ENGINEERING SERVICES SPATIALS

47359_ESP_01 - 461 Chapel Road, Bankstown

Date 23.01.2025 - Revision 1

PROJECT
461 CHAPEL ROAD, BANKSTOWN, NSW 2200
 DRAWING TITLE
ENGINEERING SERVICES SPATIALS - LEVEL 09

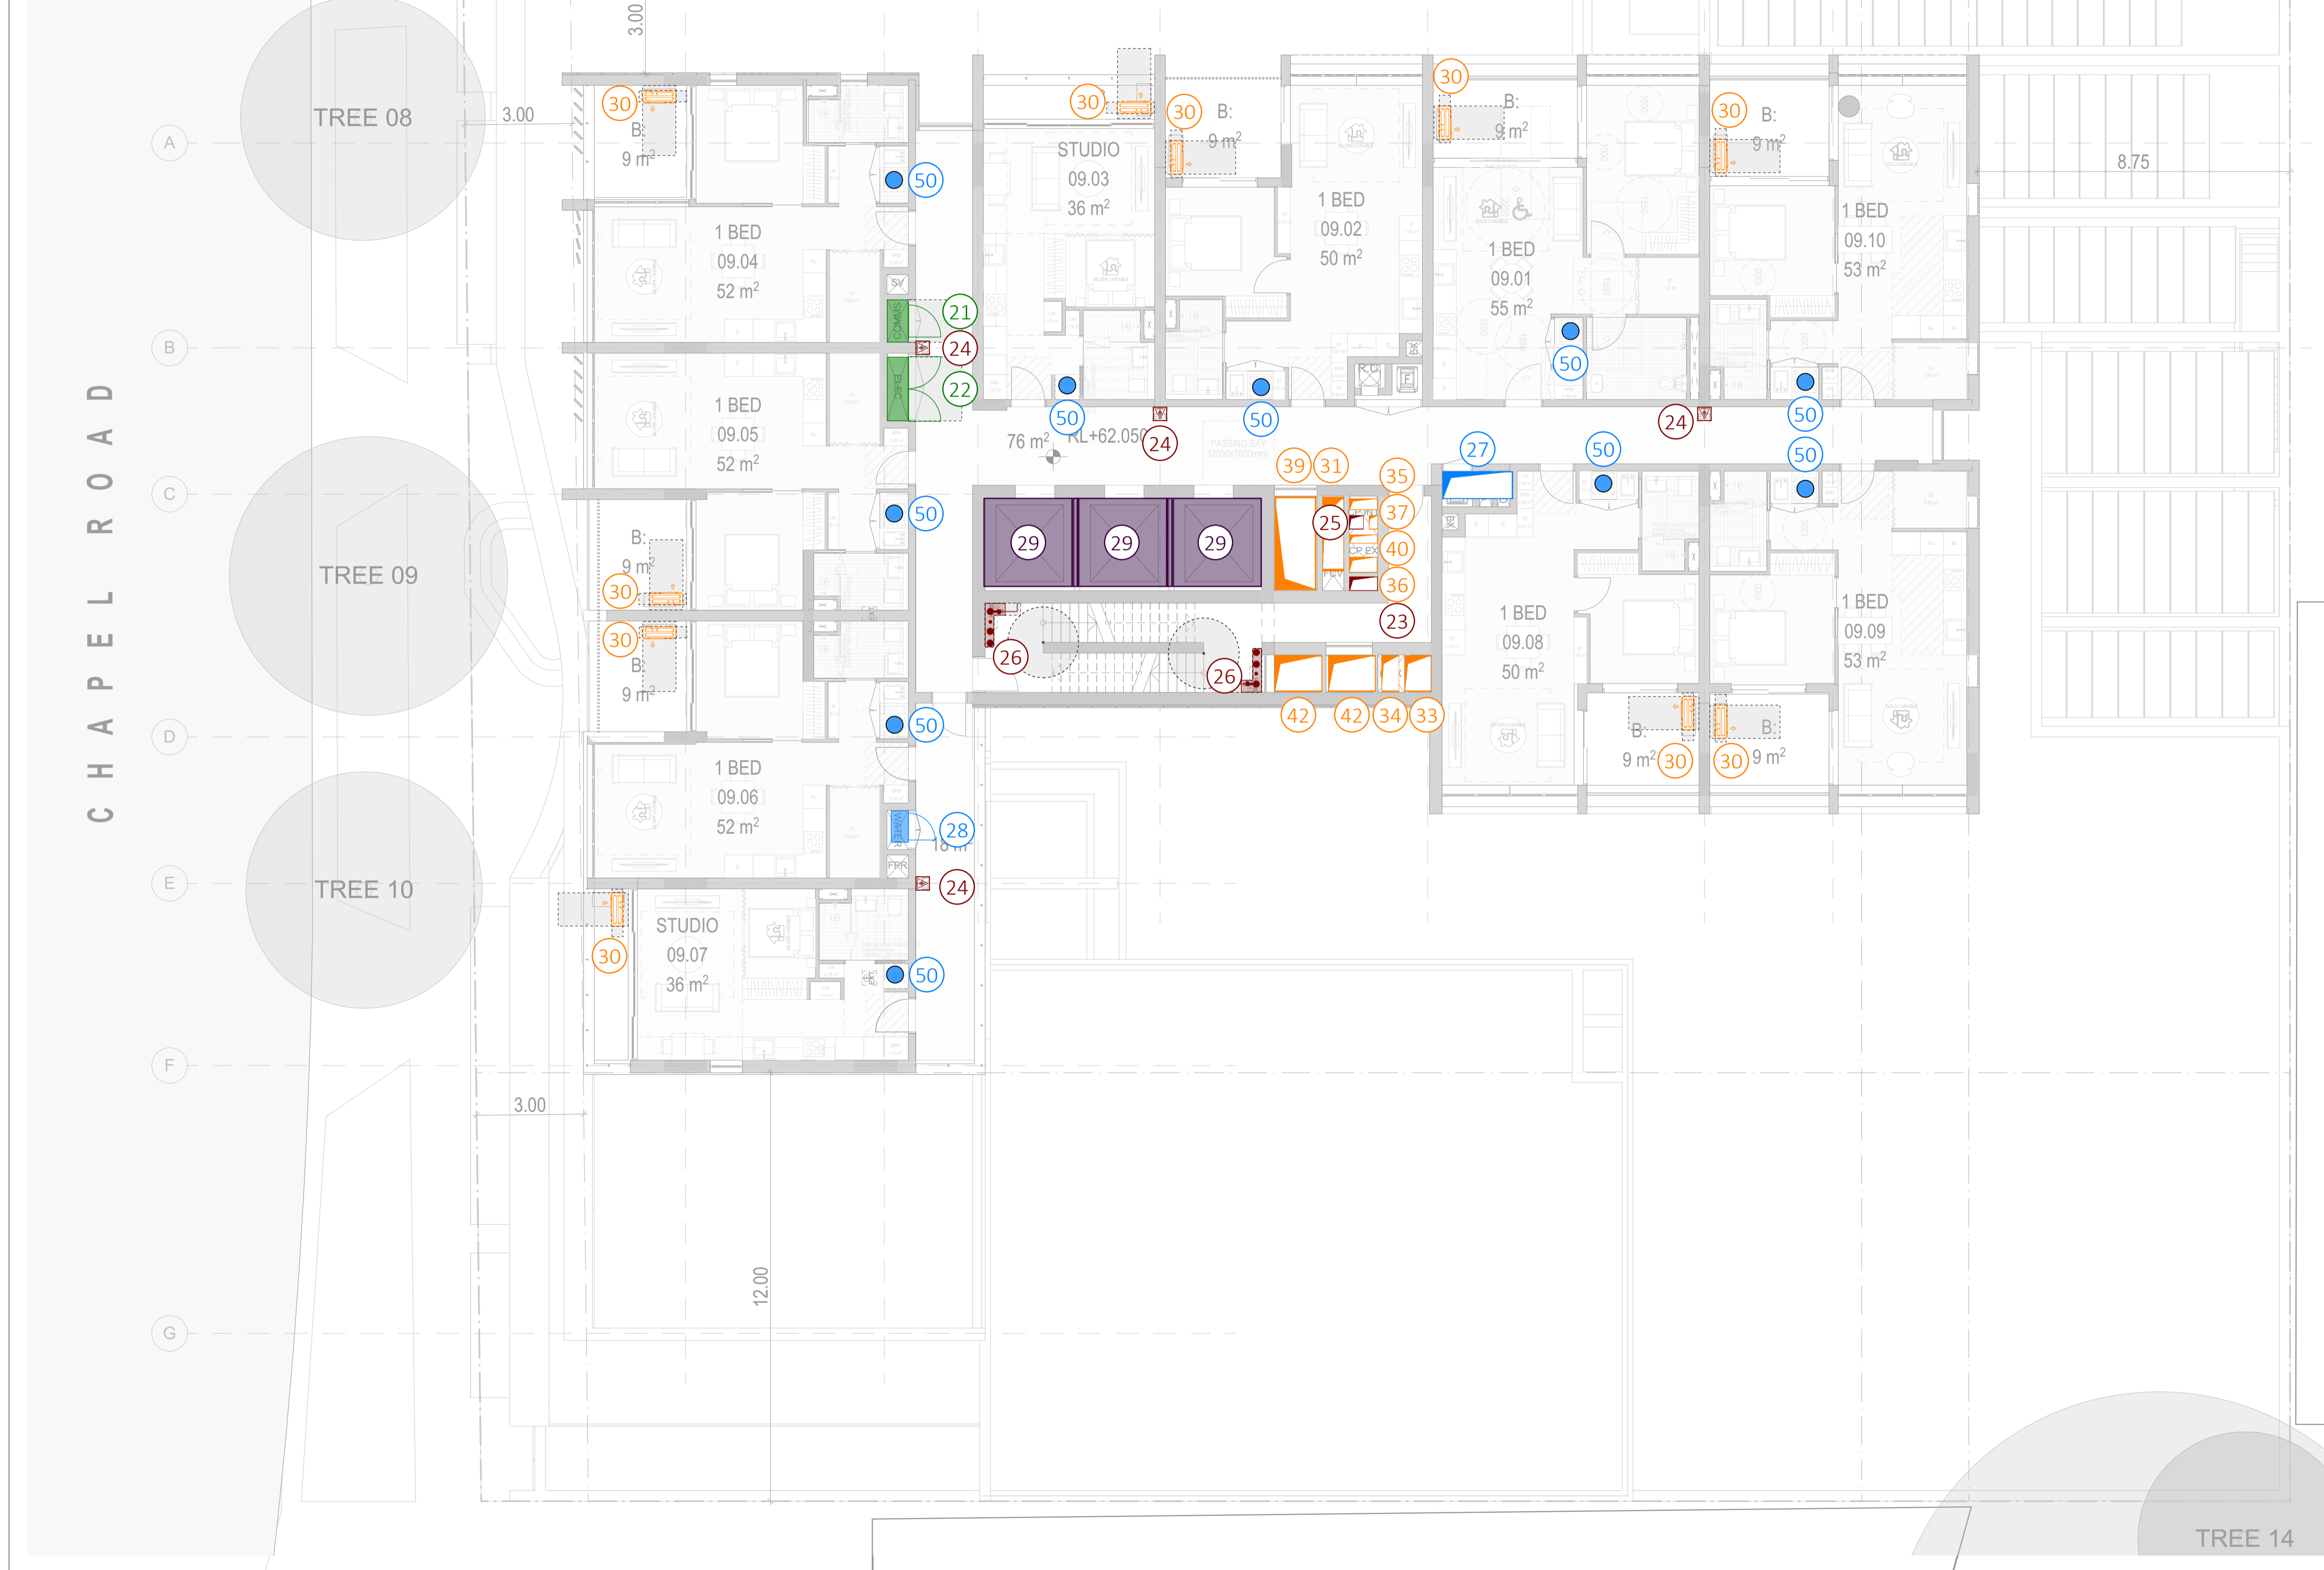
Action Reference No.	Action	Issue Status
C1	Egress around fire tanks is under review. Columns to be revised as indicated. We recommend relocating the OSD tank to allow for the fire tank arrangement as shown.	Open
C2	Columns in switch room to be reviewed. If columns need to remain, the switch room may need to get deeper.	Open
C3	Egress design compliance to be confirmed. We recommend having a direct egress path to the fire control room from outside, to be confirmed by BCA.	Open
C4	We recommend allowing for traffic bollards around the substation due to the proximity to the vehicle travel path.	Open
C5	Carpark exhaust fans to be located at high level. To be coordinated with waste room layout and garbage chute locations.	Open
C6	Stair pressurisation fans to be stacked as shown.	Open
C7	Carpark intake to be coordinated with landscaping in communal outdoor space.	Open
C8	Plant to be reviewed by acoustics to determine acoustic treatment required for space. Intent for plant space to be open to above to allow for ventilation to plant.	Open

C9	Access to roof to have integrated ladder complete with handrail. We recommend egress paths to rooftop to be reviewed by BCA.	Open
C10	No built form is permitted above kiosk substations. To retain substations as kiosk type, extent of building to be reviewed.	Open
C11	900mm clear trench is required below the kiosk to allow for HV feeder from authority connection, and between kiosk and main switch room. This will result in a low head height area as shown.	Open
C12	Cupboards are required to transition on level to connect to basement level. Transition and riser location to be coordinated with architecture	Open
C13	Anything within the 3m radius of the kiosk substations is required to be blast proof. Location and extent of roller shutter door to be reviewed to ensure this is not within the blast radius.	Open

PROJECT
461 CHAPEL ROAD, BANKSTOWN, NSW 2200
 DRAWING TITLE
ENGINEERING SERVICES SPATIALS - LEVEL 11-22

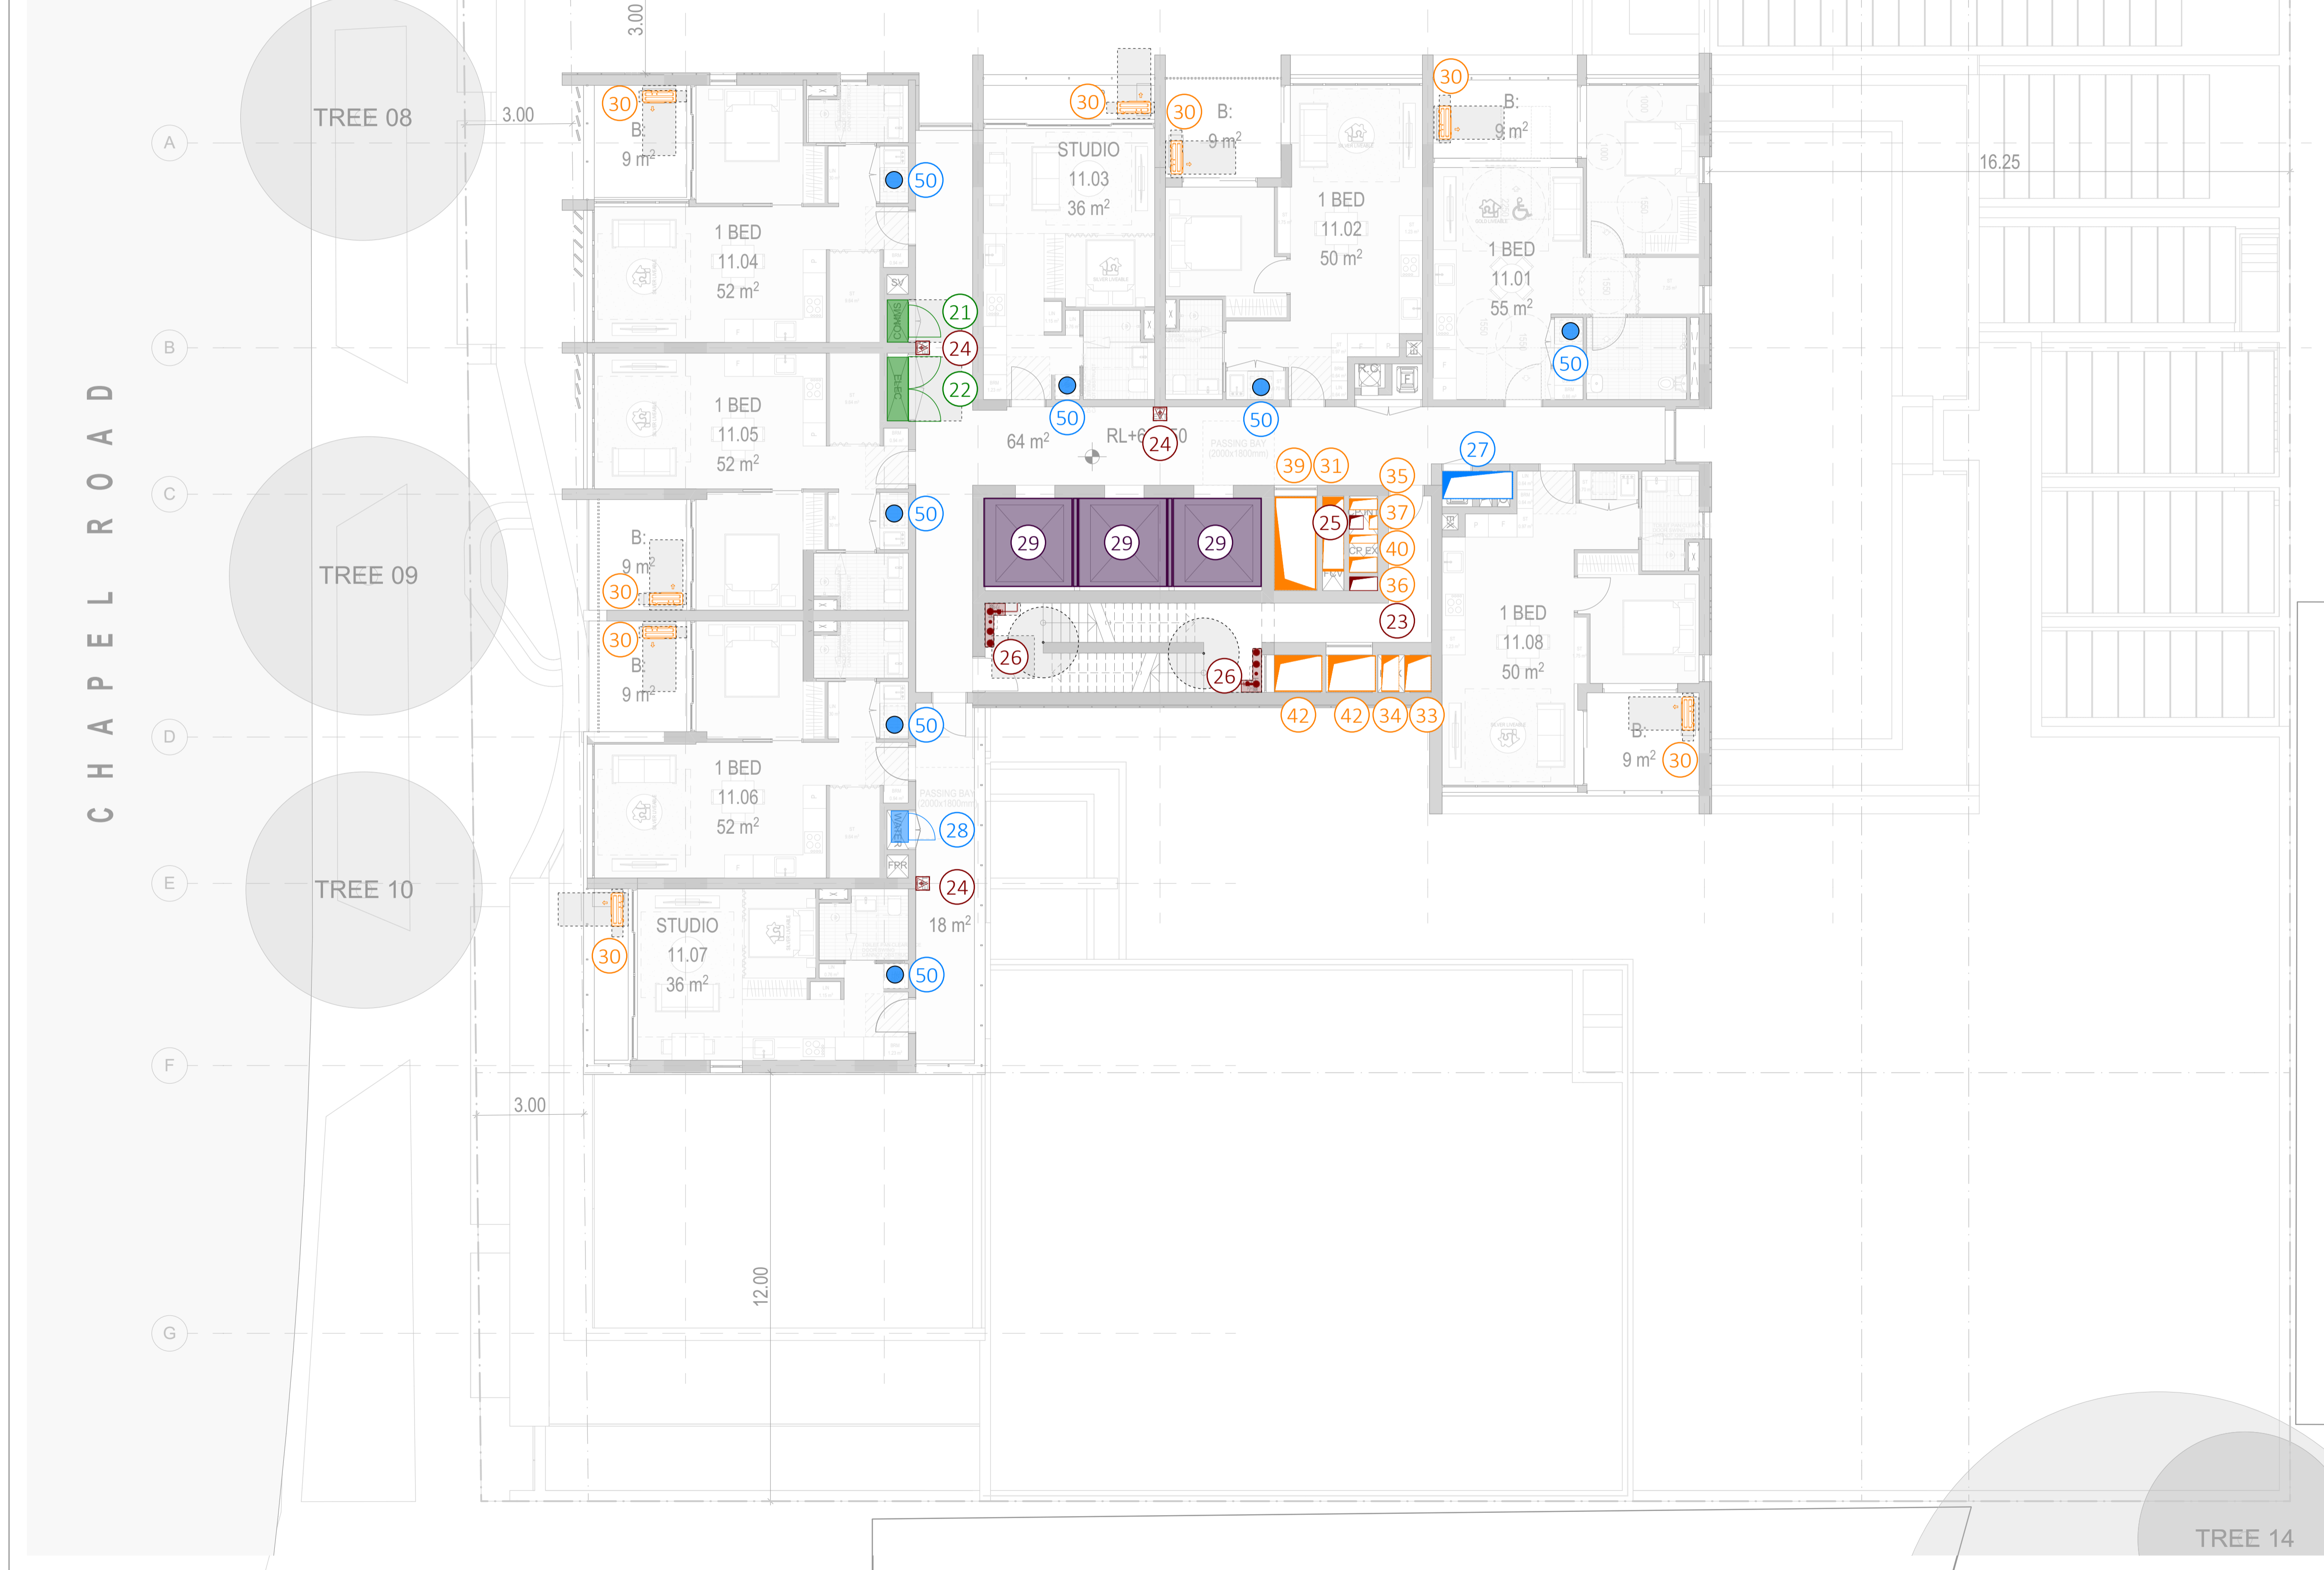
Action Reference No.	Action	Issue Status
C1	Egress around fire tanks is under review. Columns to be revised as indicated. We recommend relocating the OSD tank to allow for the fire tank arrangement as shown.	Open
C2	Columns in switch room to be reviewed. If columns need to remain, the switch room may need to get deeper.	Open
C3	Egress design compliance to be confirmed. We recommend having a direct egress path to the fire control room from outside, to be confirmed by BCA.	Open
C4	We recommend allowing for traffic bollards around the substation due to the proximity to the vehicle travel path.	Open
C5	Carpark exhaust fans to be located at high level. To be coordinated with waste room layout and garbage chute locations.	Open
C6	Stair pressurisation fans to be stacked as shown.	Open
C7	Carpark intake to be coordinated with landscaping in communal outdoor space.	Open
C8	Plant to be reviewed by acoustics to determine acoustic treatment required for space. Intent for plant space to be open to above to allow for ventilation to plant.	Open

C9	Access to roof to have integrated ladder complete with handrail. We recommend egress paths to rooftop to be reviewed by BCA.	Open
C10	No built form is permitted above kiosk substations. To retain substations as kiosk type, extent of building to be reviewed.	Open
C11	900mm clear trench is required below the kiosk to allow for HV feeder from authority connection, and between kiosk and main switch room. This will result in a low head height area as shown.	Open
C12	Cupboards are required to transition on level to connect to basement level. Transition and riser location to be coordinated with architecture	Open
C13	Anything within the 3m radius of the kiosk substations is required to be blast proof. Location and extent of roller shutter door to be reviewed to ensure this is not within the blast radius.	Open
